BUILDING PERMIT COVER PAGE

MHP 23022Development Services Department
Building Permit and Inspection Services

ZADORRA ESTATE INC.
CITY OF OSHAWA

MODEL:
RIVER 2

TITLE SHEET

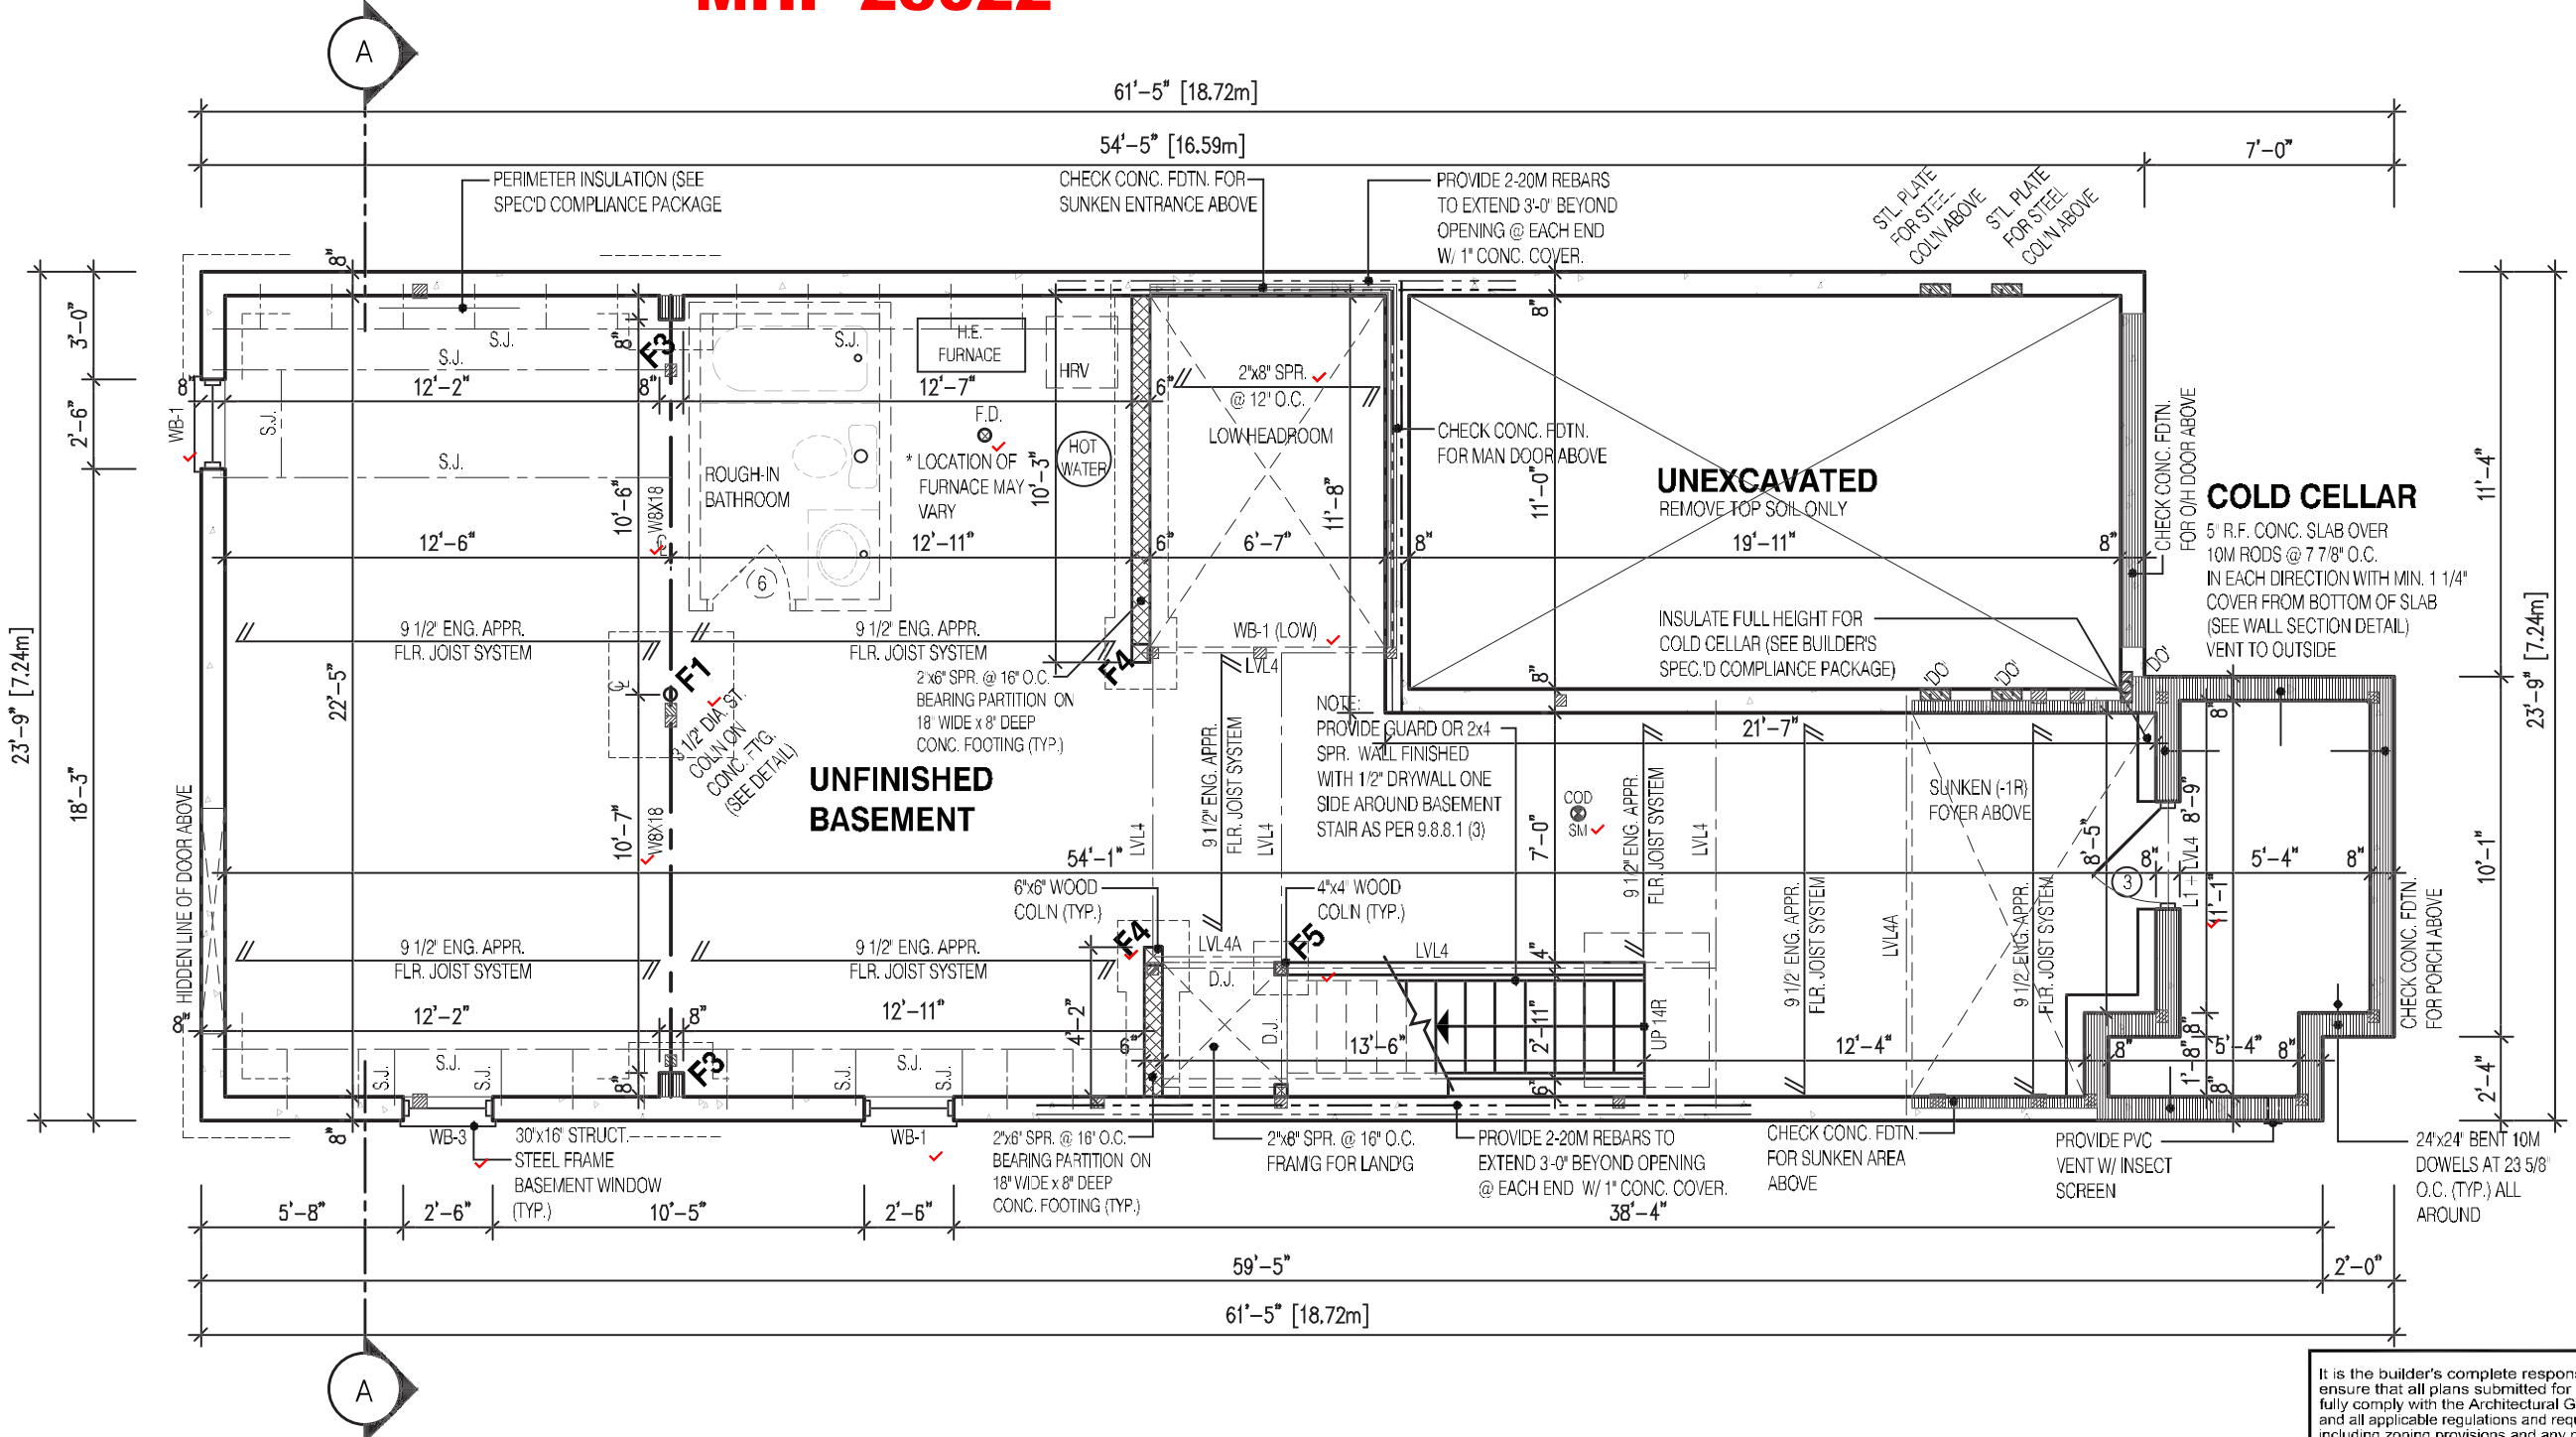
SOIL CONDITIONS SHALL BE VERIFIED BY A PROFESSIONAL ENGINEER COMPETENT IN THE FIELD OF SOIL ENGINEERING, PRIOR TO PLACING ANY FOUNDATION.

THE PERMIT PLANS HAVE BEEN REVIEWED FOR ONE (1) DWELLING UNIT. ANY FUTURE CHANGES WILL REQUIRE A SEPARATE BUILDING PERMIT

RAIN WATER DOWNSPOUTS ARE TO BE DISCHARGED AT GRADE AND NOT CONNECTED TO WEEPING TILES.

A SEPARATE BUILDING PERMIT IS REQUIRED FOR ANY PROPOSED INTERIOR PARTITIONS AND/OR ALTERATIONS.

IT IS RECOMMENDED THAT CRUSHED CONCRETE OR SLAG AGGREGATE **NOT** TO BE USED FOR BACKFILL UNDER CONCRETE SLABS, AROUND SEWER LATERALS OR WEEPERS.

UPON COMPLETION OF THE FOUNDATION, A SURVEY PREPARED BY AN ONTARIO LAND SURVEYOR INDICATING THE LOCATION OF THE BUILDING TO ALL PROPERTY LINES IS REQUIRED TO BE SUBMITTED TO THE BUILDING DEPARTMENT

A CURSORY REVIEW OF THE STRUCTURAL ELEMENTS HAS BEEN COMPLETED AND IS RELIANT ON ENGINEER'S CERTIFICATION OF DRAWINGS.
